**Re: Buckley Yard Pre-Application Review Comments (Pre-Application Meetings #1429824 / #1480283)**

## RainTree Pre-App Comments

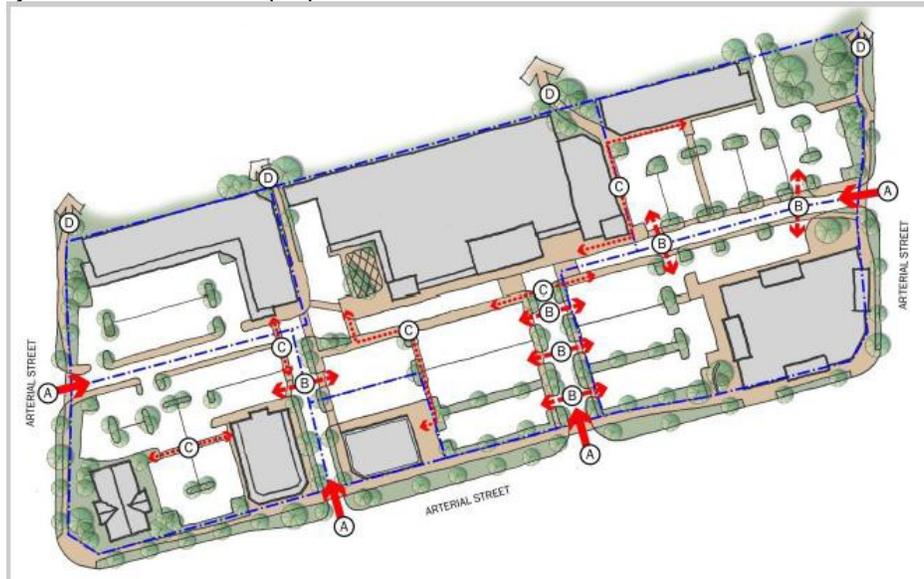
Double frontage lots are not permitted on local and collector streets and staff strongly supports the homes facing west along the north-south street that transitions to the commercial area.

**Response: Noted, thank you.**

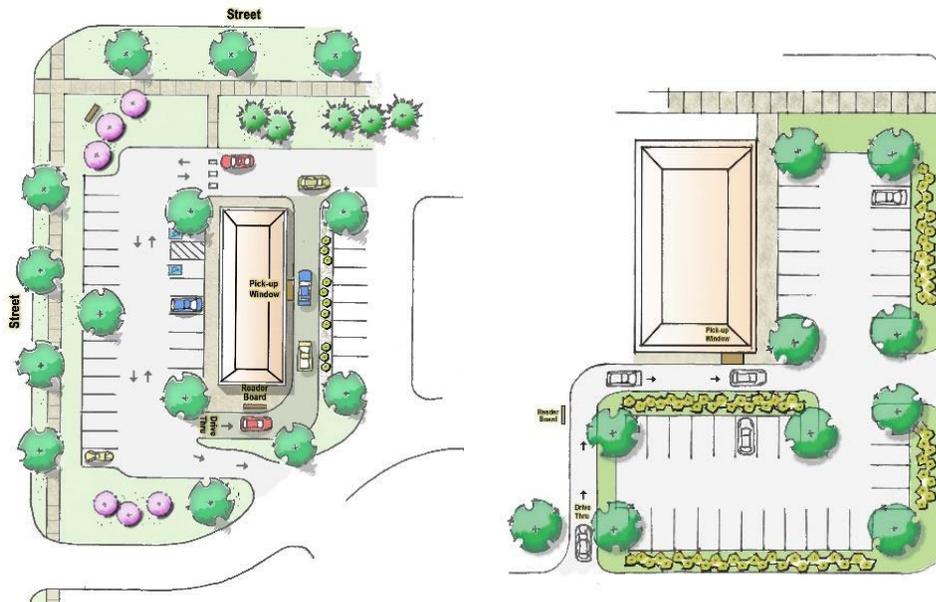
- b. A decorative masonry wall between 3'- 4' tall in combination with landscaping.

**Response: This comment will be addressed with a later submittal.**
